Intel386™ EX EMBEDDED PROCESSOR SPECIFICATION UPDATE

Order Number: 272873-004

The Intel386™ EX Embedded Processor may contain design defects or errors known as errata. Characterized errata that may cause the Intel386 EX Embedded Processor's behavior to deviate from published specifications are documented in this specification update.

1. *Watchdog Timer (WDT) Bus Monitor Failure During Bus Pipeline Operation*

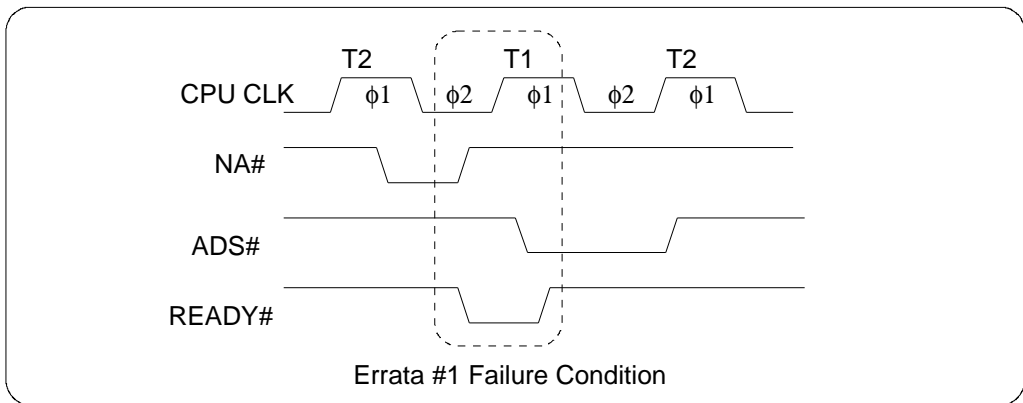
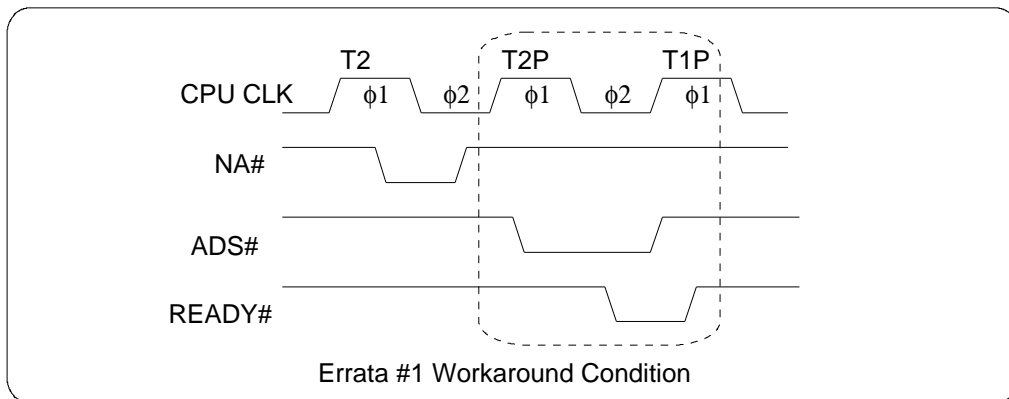
PROBLEM: The errata applies to the WDT unit when using the Bus Monitor Mode and Bus Pipeline operation. If a pipelined bus cycle is requested at the same time the current bus cycle is completed, the WDT down counter is not reloaded or stopped. This condition means that the WDT could time-out and erroneously report a system failure. The waveform below shows the errant condition.

The errata condition is caused by the system generating READY# immediately after NA# has been requested, and a T1 cycle is generated (rather than a T2P cycle). Essentially, the system is requesting a pipelined access, but does not need it because READY# has been returned. Such a condition is not typically expected when using the pipeline feature.

IMPLICATION: Applications that use the bus monitor mode of the WDT need to be aware of this condition. If bus pipelining is not used, the errata can be ignored. If bus pipelining is used, look to the workaround description below to ensure the errata condition is avoided.

WORKAROUND: Ensure that READY# is not generated after a pipelined bus operation is requested. See the example waveform below.

3. *WDT Lockout Sequence May Not Properly Reload Down Counter*

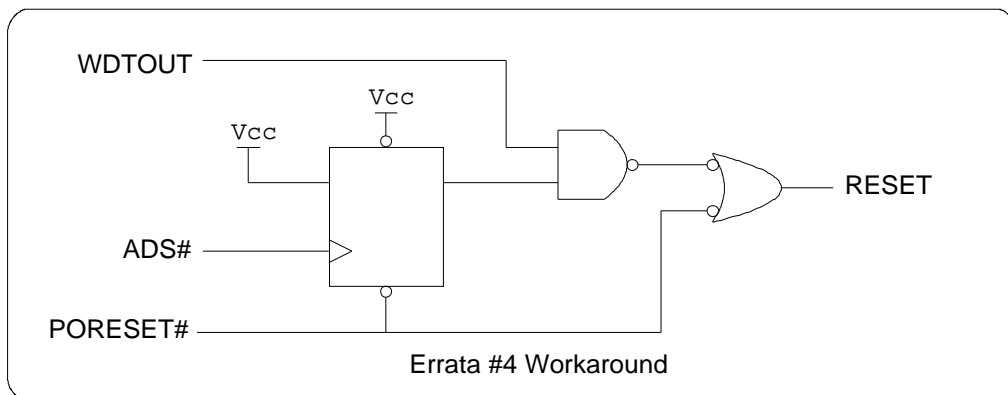
PROBLEM: If the WDT is in general timer mode or bus monitor mode, and the CLKDIS bit is set (i.e., counter is stopped), enabling the system watchdog mode by executing the lockout sequence does not reload the down counter. This means the counter will start counting down from whatever the previous value was in the counter (rather than starting from the value in the reload counter).

WORKAROUND: There are two possible workarounds. Executing two lockout sequences will reload the counter correctly. Essentially the first lockout sequence enables the WDT, while the second sequence reloads the counter. Another workaround that requires less code is to enable the counter first by clearing the CLKDIS bit, and then execute the lockout sequence (see code example below).

```
MOV    DX, WDTSTATUS
IN     AL, DX           ; Read WDT status register
AND    AX, 0FCH        ; Clear clock dis/bus mon bits
OUT    DX, AL          ; Update register
MOV    DX, WDTCLR
MOV    AX, 0F01EH
OUT    DX, AX
MOV    AX, 0FE1H
OUT    DX, AX          ; Lockout Sequence
```

13. DSR1#/STXCLK Pin Has A Permanent Weak Pull-Up

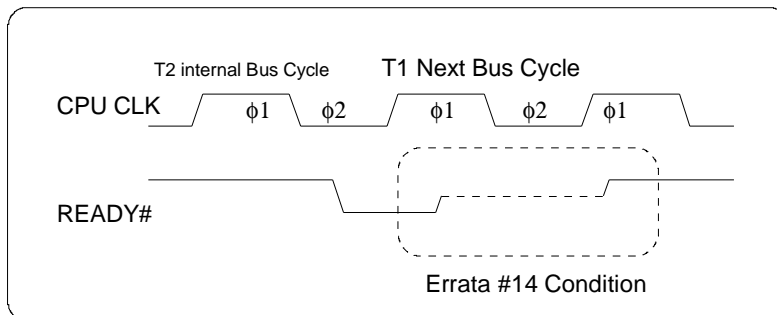
PROBLEM: The weak pull-up device used to hold the state of the DSR1#/STXCLK pin at a high level until device configuration is complete does not turn off. This condition results in a higher than normal leakage current for the pin.

WORKAROUND: None. The external driver must be strong enough to pull down the pin. The weak pull-up is approximately 5 KOhms.

30. *HLDA Inactive To HOLD Active Arbitration Could Improperly Float The Bus*

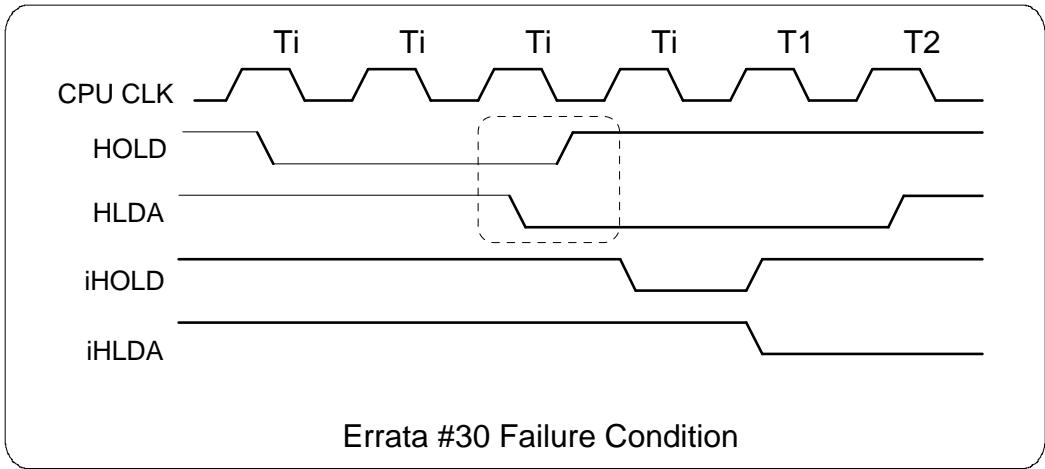
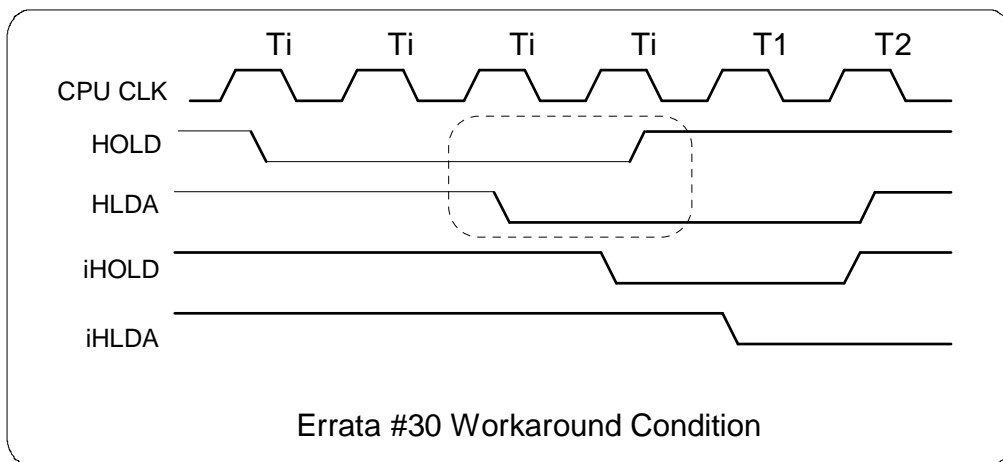
PROBLEM: In a HOLD/HLDA cycle the HOLD signal must not be re-asserted until after HLDA is returned inactive. If, however, HOLD is asserted in the same T-state that HLDA goes inactive a problem may occur where the bus arbiter relinquishes control to the core and at the same time floats the bus by asserting the HLDA pin. The following waveform shows the conditions that cause this error. The signals iHOLD and iHLDA are internal signals and represent the HOLD input to the core and the HLDA output from the core (equivalent to the HOLD and HLDA signals on a Intel386™ SX processor). In this diagram a T1 occurs because a request was pending by the core during the previous HOLD cycle. One T-state after the arbiter releases the bus (HLDA = 0) it removes its iHOLD, and then the core removes iHLDA. As soon as the iHLDA is released, the T1 state starts. However, because of the timing of the next HOLD request, the bus arbiter re-asserts iHOLD and HLDA even though the core has not asserted iHLDA. The result is that the core continues to run its bus cycle and, at the same time, the bus arbiter has floated the external bus. It is also possible for the following to occur when HOLD/HLDA arbitration is at issue: HOLD is driven active during the T1 or Tw of a valid bus cycle. The processor begins the next bus cycle and generates HLDA. HLDA is active for only one T-state. ADS# is extended through the bus cycle. The alternate bus master sees the HLDA and performs its bus activity. HOLD is then driven inactive and the bus is returned to the Intel386™ EX Processor. At this point there is bus contention.

It is also possible for the following to occur when HOLD/HLDA arbitration is an issue: HOLD is driven active during the T₁ or T_w of a valid bus cycle. The processor begins the next bus cycle and generates HLDA. HLDA is active for only one T-state. ADS# is extended through the bus cycle. The alternate bus master sees the HLDA and performs its bus activity. HOLD is then driven inactive and the bus is returned to the Intel386™ EX Processor. At this point there is bus contention.

WORKAROUND: Synchronize the external HOLD request such that it is does not go active until at least one T-state after HLDA is inactive. See the following example waveform.

Another workaround is to delay the generation of HOLD until the last T2-state of a valid bus cycle (excluding refresh cycles or INTA cycles).

Figure 3. HOLD with Short REFRESH Interval

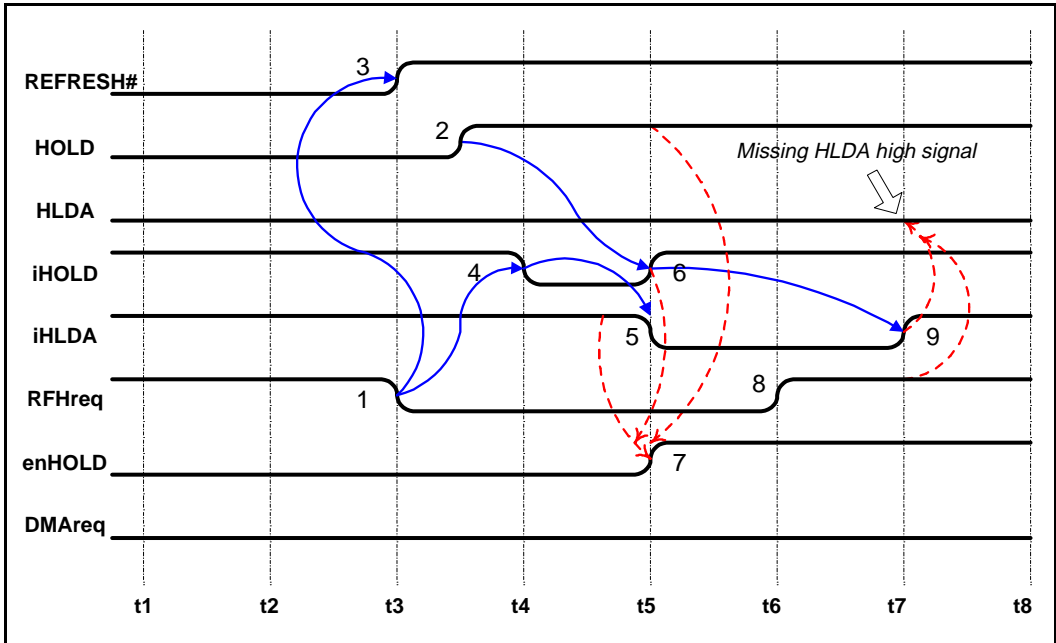
Figure 3 shows Condition #1a where an external HOLD and refresh request conflict can occur. The table below describes each signal name used:

Figure 4. Quick HOLD Assert and Deassert with Slow REFRESH Interval

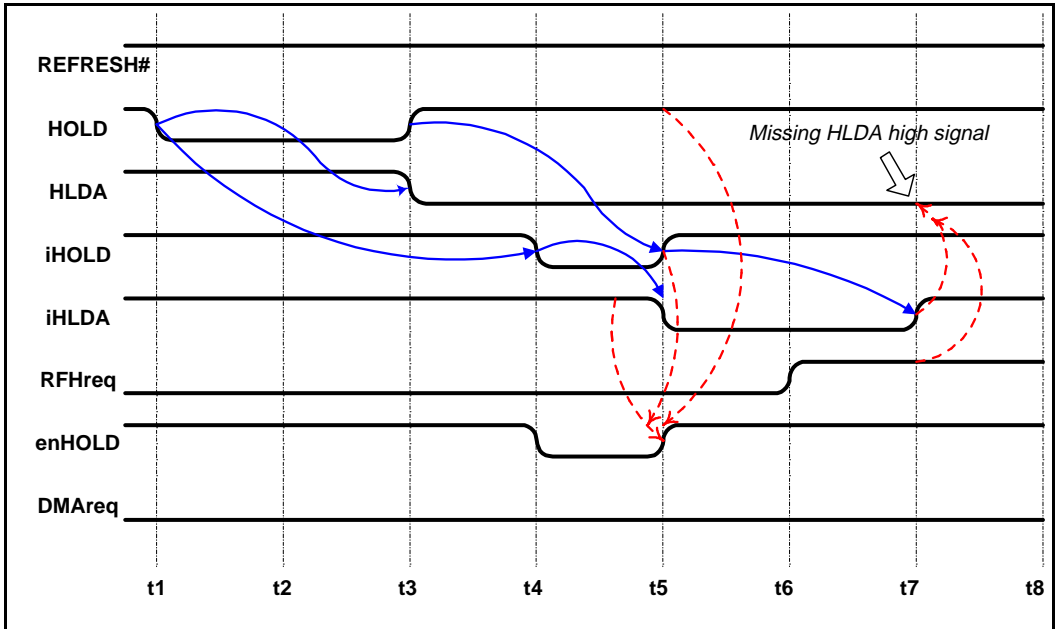
- B. HOLD is removed and reasserted within one bus cycle. Refer to Figure 4. This condition will cause the problematic window with fast iHOLD deassertion (t4) and assertion (t5). Note that if HOLD is deasserted because of pending REFRESH and reasserted again within one bus cycle, the problem will not occur since the iHOLD signal is never deasserted due to refresh. The reassertion of the HOLD would then be serviced upon completion of the refresh.

Figure 5. DMA, HOLD and REFRESH with Normal Interval

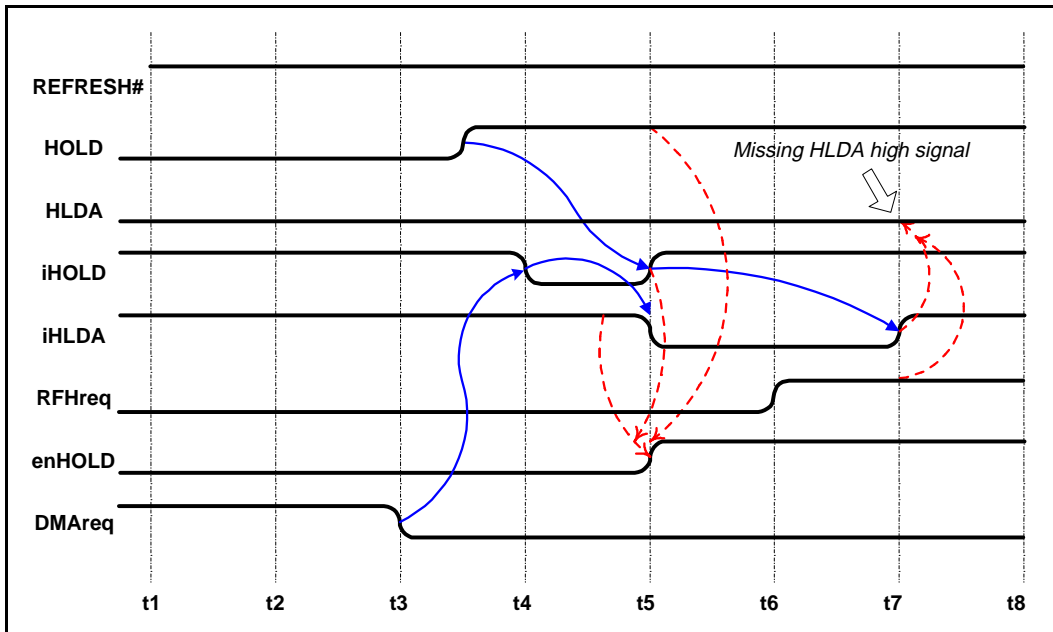
For the errata to occur, HOLD must be asserted asynchronously at any cycle such as in an idle cycle. Refer to Figure 5. Termination of DMAREQ at time t3 with assertion of HOLD at time t4 creates the problematic window. If there is a refresh request at time t6, the HLDA is blocked and will not go active at time t7. If HOLD is synchronized at the beginning of a new valid bus cycle (except for REFRESH), HLDA will always be asserted since the problematic window will not occur.

DMAREQ is a signal internal to the processor. This signal is not always within the user's control and could be internally deasserted, such as in autoinitialize mode. To avoid issues

with this type of situation, it is recommended that the user deassert the external request DREQ after the last transfer has completed. It is further recommended that DREQ only be deasserted after a valid DMA acknowledge (DACK# goes low) has been returned. If a DREQ is held active and then deasserted during or shortly after the autoinitialize sequence, the problematic window can be induced and cause the errata to occur. See errata #28 for additional details on DMA programming restrictions.

10. 272485-002, Section 6.3.6, Page 6-29, Figure 6-11.

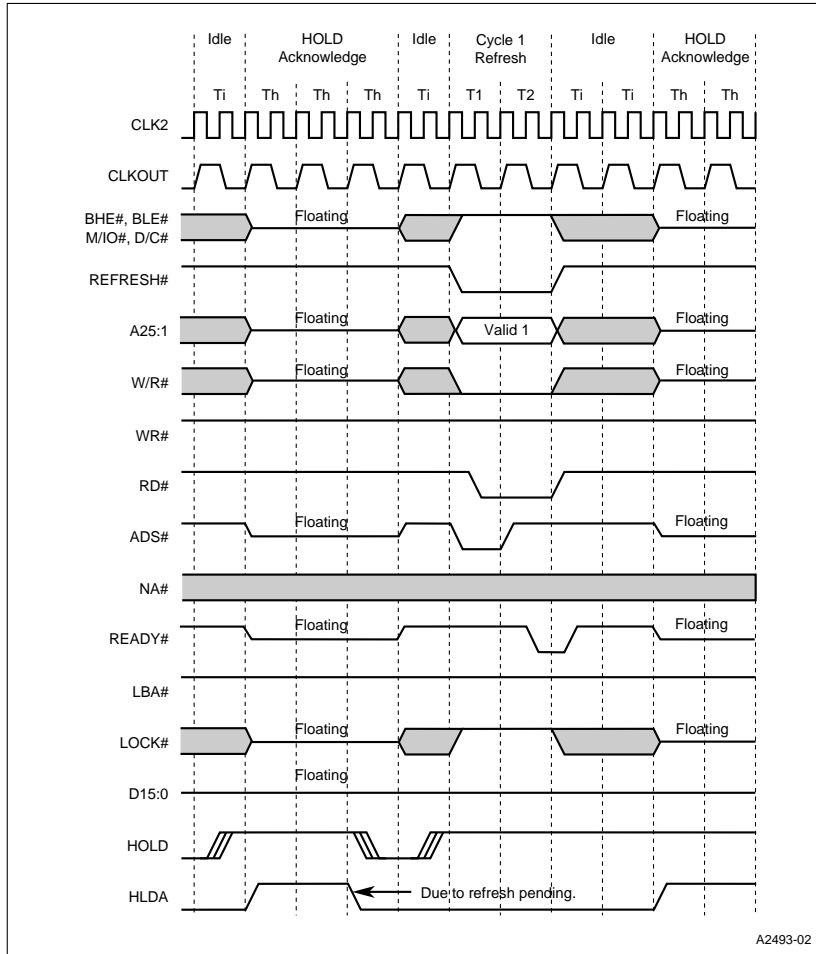
ISSUE: Changed "BHE#, BLE#, M/IO#, D/C#" to read "UCS#, CS6:0, BHE#, BLE#, M/IO#, D/C#".

27. 272485-002, Section 13.2.2.1, Page 13-9

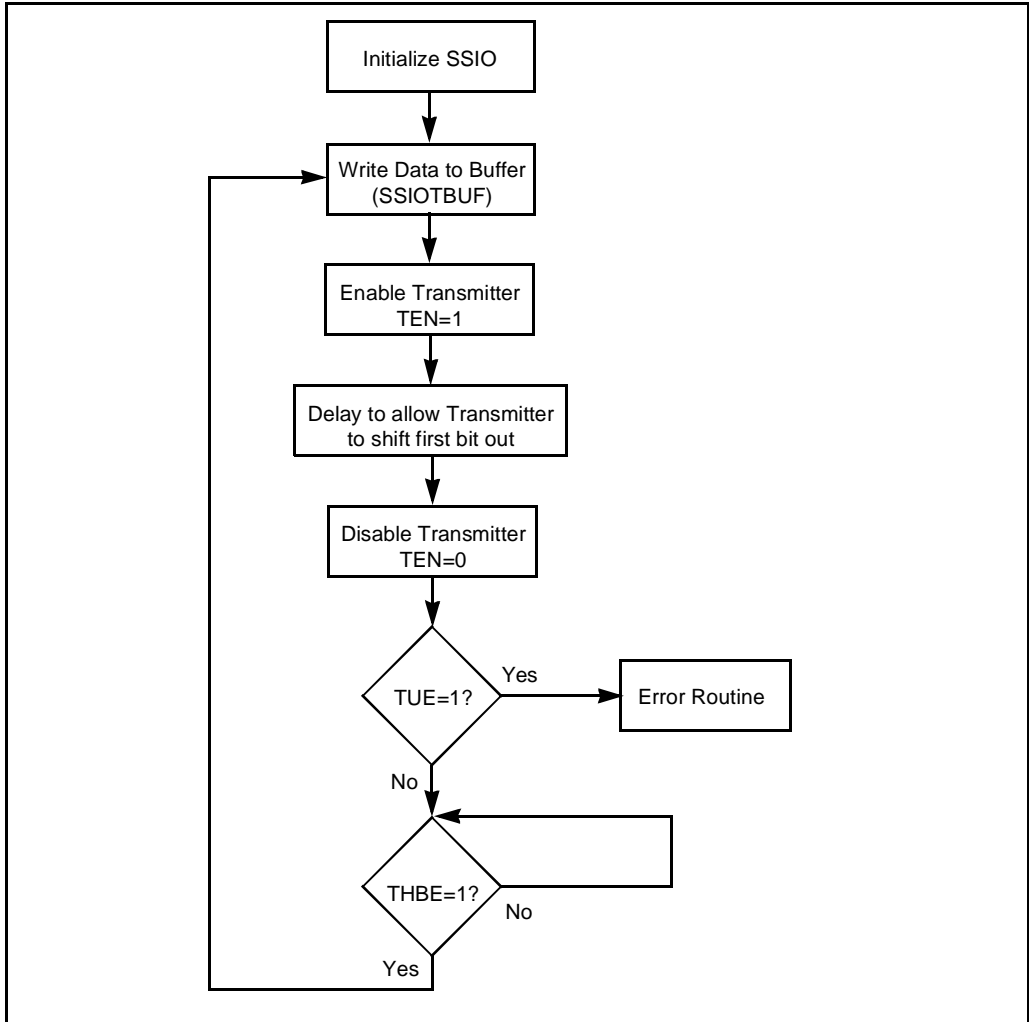
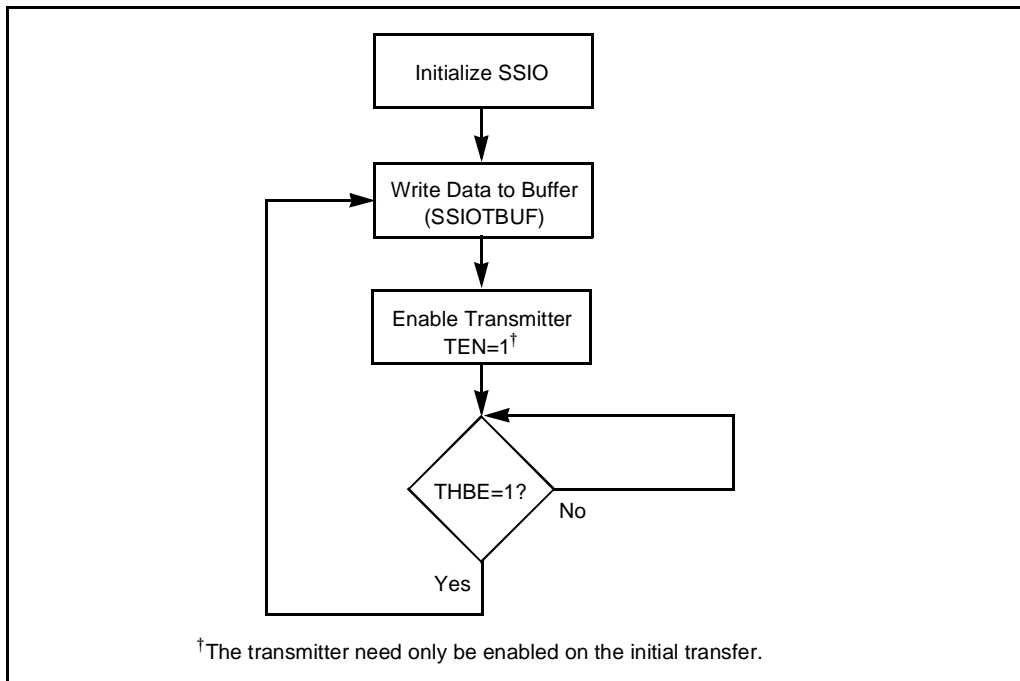
ISSUE: Replace figure 13-8 with Figures 13-8a and 13-8b as shown below.
